DATE: March 9, 2010
TO: Michael J. Gillis, Virginia Correctional Enterprises Document Management Services
FROM: Jo Anna Ripley, Stormwater
PO: 270712
RE: Files Approved for Scanning

General File ID or BMP ID: PC054

Saint Georges Hundred
Saint Thomas Hundred Common Area Section 5
Phase 3

CODE COMPLIANCE PLAN REVIEW COMMENTS
ST. GEORGE'S HUNDRED, SECTION 5, PHASE III
PLAN NO. S-64-91
OCTOBER 8, 1991 DEC

DRAINAGE, SEDIMENT AND EROSION CONTROL PLAN
ST. GEORGE'S HUNDRED
 SECTION 5, PHASE III
 OWNER/DEVELOPER: JAMES R. CHESMAN DEVELOPMENT COMPANY
 BERKELEY DISTRICT

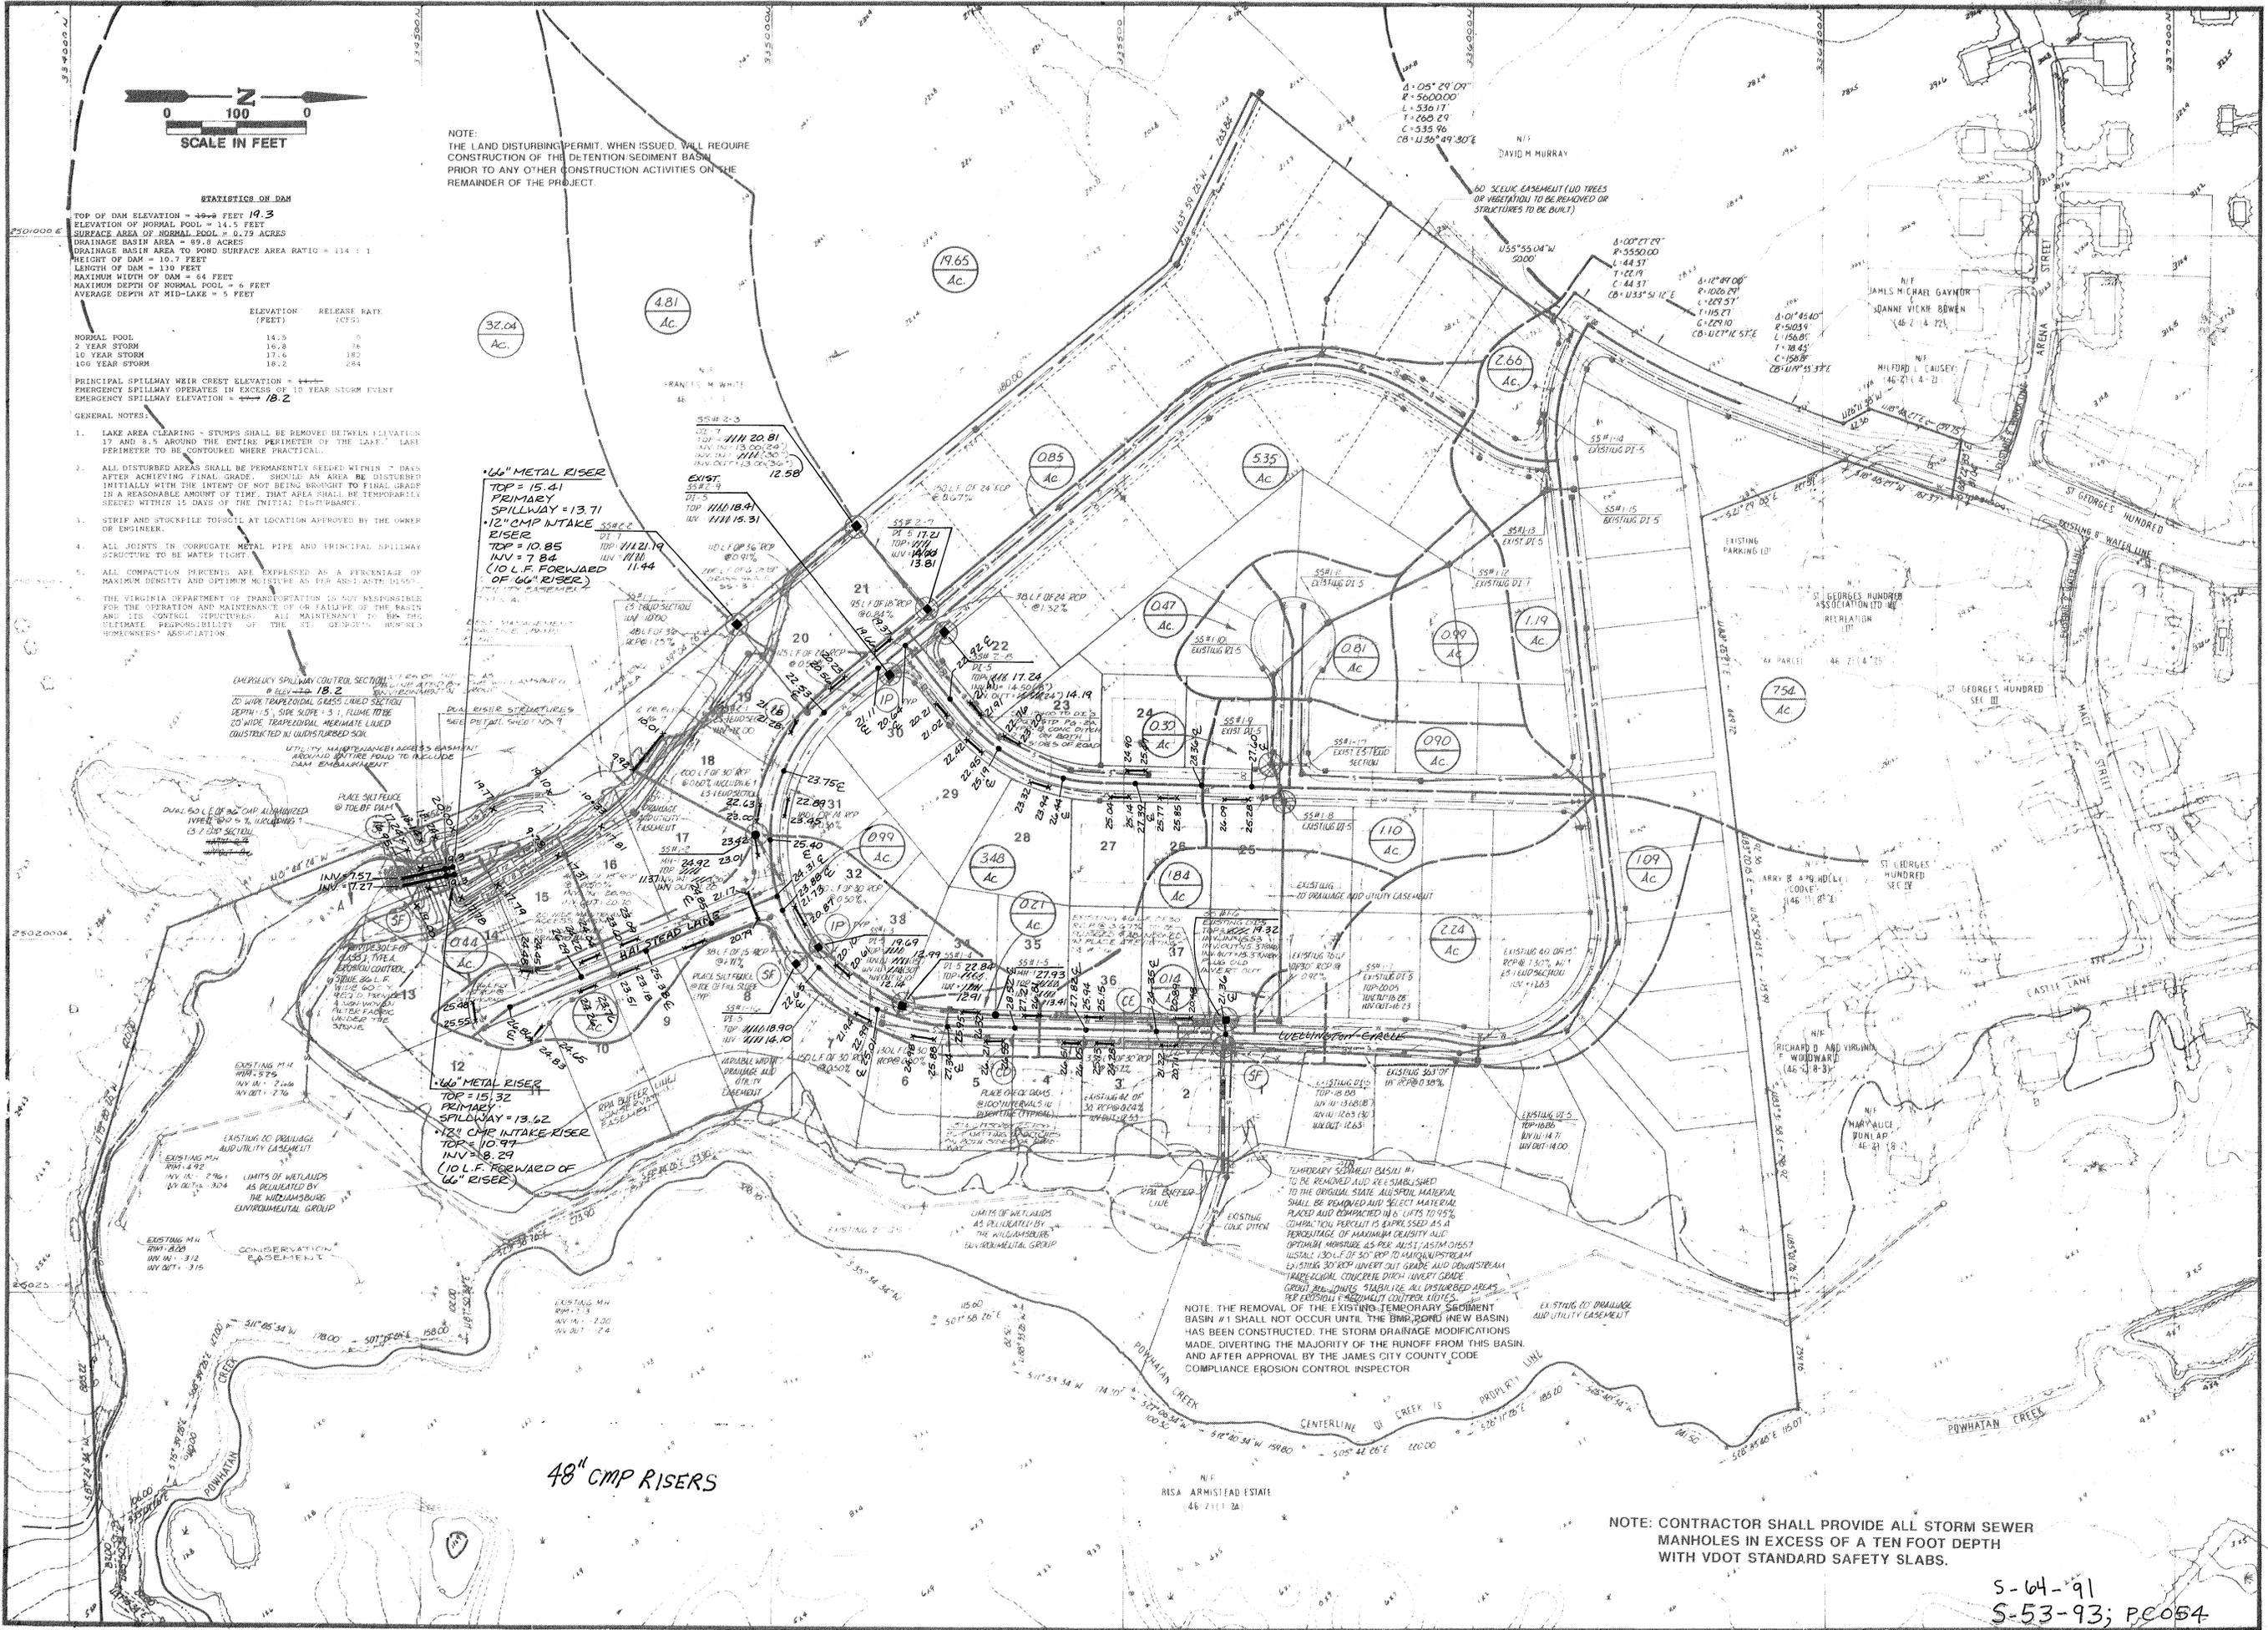
10. Modify General Note 2 on Sheet 5 regarding the dam construction to state that permanent seeding will occur within 7 days not 30 after achieving final grade.

- ALL DISTURBED AREAS SHALL BE PERMANENTLY SEEDED WITHIN 7 DAYS AFTER ACHIEVING FINAL GRADE. SHOULD AN AREA BE DISTURBED INITIALLY WITH THE INTENT OF NOT BEING BROUGHT TO FINAL GRADE IN A REASONABLE AMOUNT OF TIME, THAT AREA SHALL BE TEMPORARILY SEEDED WITHIN 15 DAYS OF THE INITIAL DISTURBANCE.
